PSU Supplemental

PSU-2 Original Design

PSU-2 New Design

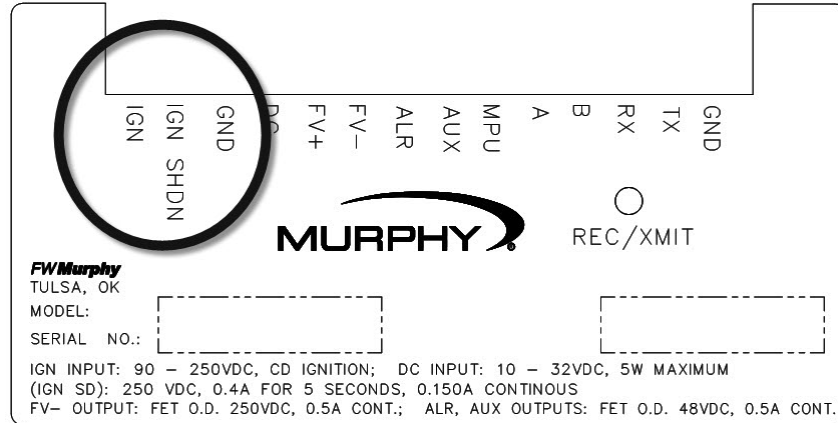
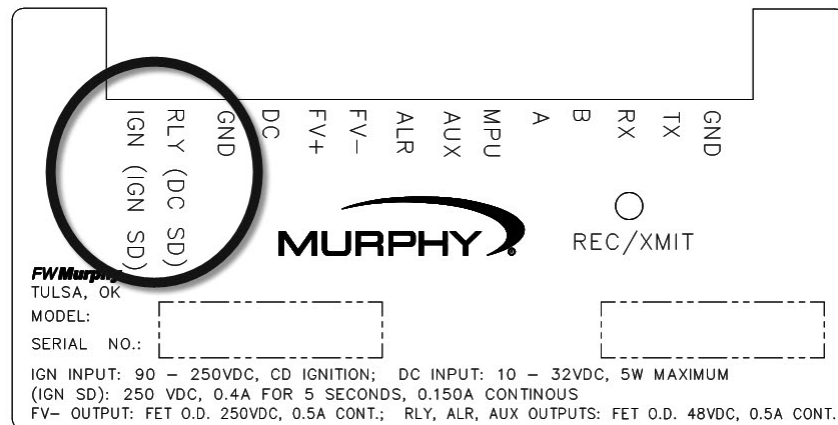
- If the PSU-2 matching the above referenced image, is being replaced by the below referenced image, **please see the reversed side of this document for wiring the new PSU-2.**

- **Setup A menu has changed.** With the change in design of the new PSU, the result is an additional output can be configured for additional application functionality. Please use IOM# 00-02-0697 for the setup configuration.

NEG GND
CD IGN SYSTEM
90VDC - 250VDC MAX

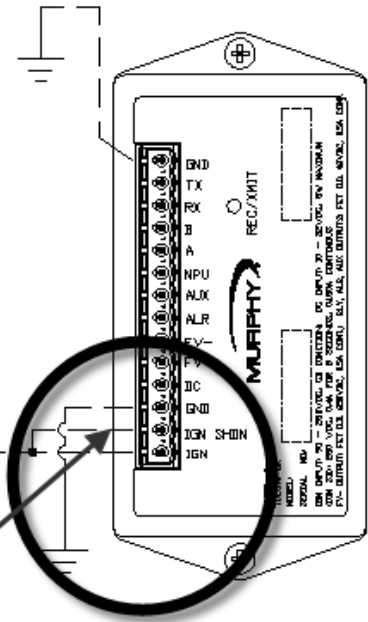
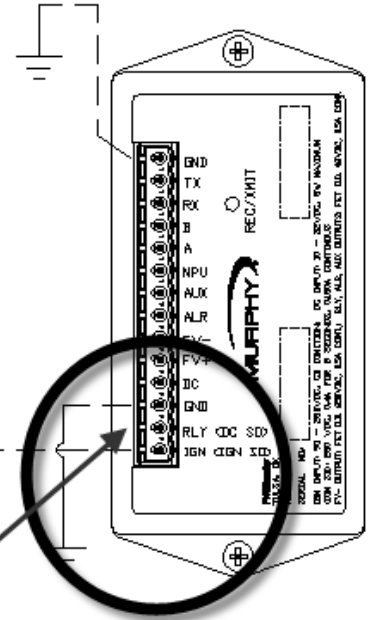
Jumper used to provide Ignition (G-Lead) grounding for shutdown

Remove jumper with new PSU design. Ignition (G-Lead) grounding for shutdown is provided on single input
